Watts Bar Nuclear Plant, Unit 2
NRC Docket No. 50-391

Subject: Watts Bar Nuclear Plant (WBN) Unit 2 – Submittal of Developmental Revision G of the Unit 2 Technical Specification (TS) and Technical Specification Bases

This letter provides Developmental Revision G of the WBN Unit 2 TS and TS Bases.

WBN Unit 2 TS and TS Bases Developmental Revision G Mark-ups

FIGURE 4.3-4
MINIMUM REQUIRED BURNUP FOR A ~~2X2~~ CHECKERBOARD ARRANGEMENT OF
2 SPENT ~~FUEL ASSEMBLIES WITH~~ 2 NEW FUEL ASSEMBLIES OF 5% ENRICHMENT
(MAXIMUM)

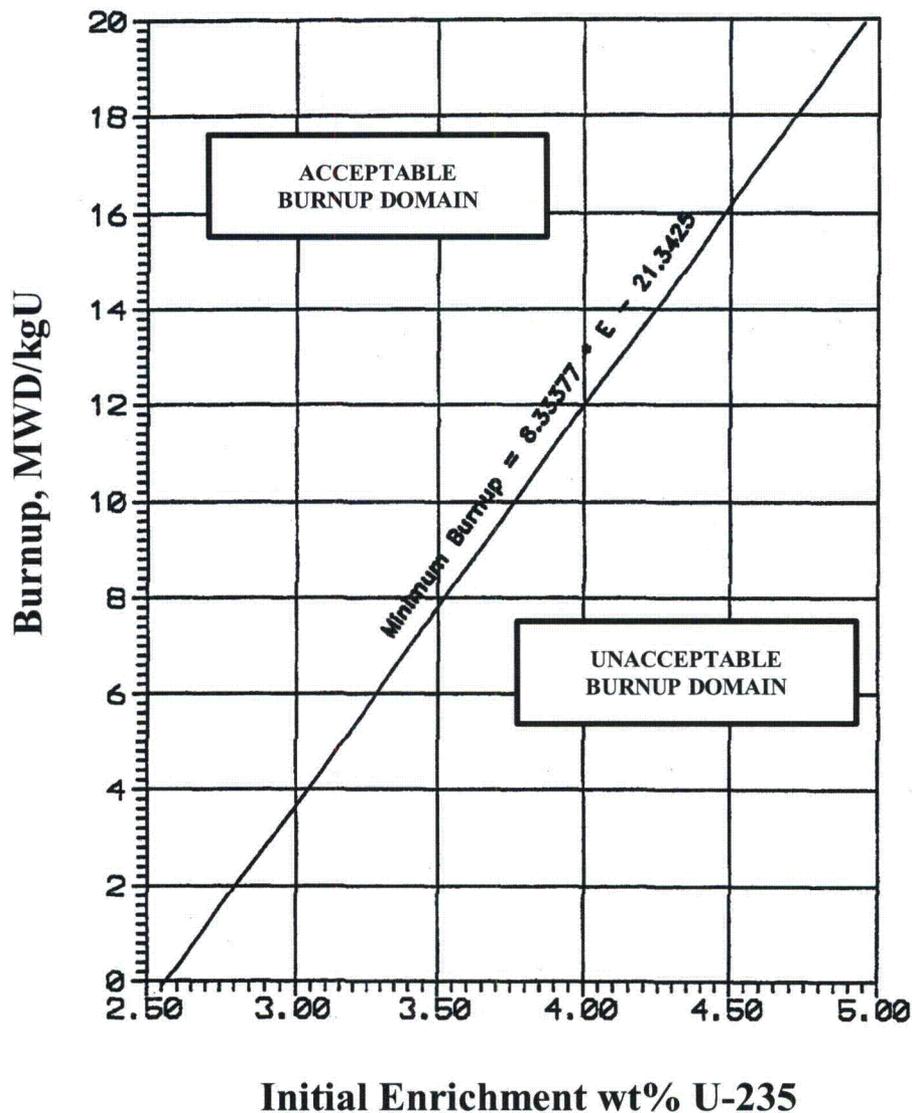
- Change to TS Bases B 3.8.4 on DC Sources to update the number of battery chargers needed for two-unit operation and to match current Unit 1 wording.
- Change to TS 4.3.1, Criticality describing acceptable spent fuel pool loading patterns.

2. New and spent fuel assemblies may be stored in a checkerboard arrangement of 2 new and 2 spent assemblies, provided that each spent fuel assembly has accumulated a minimum burnup in the acceptable domain identified in Figure 4.3-4.
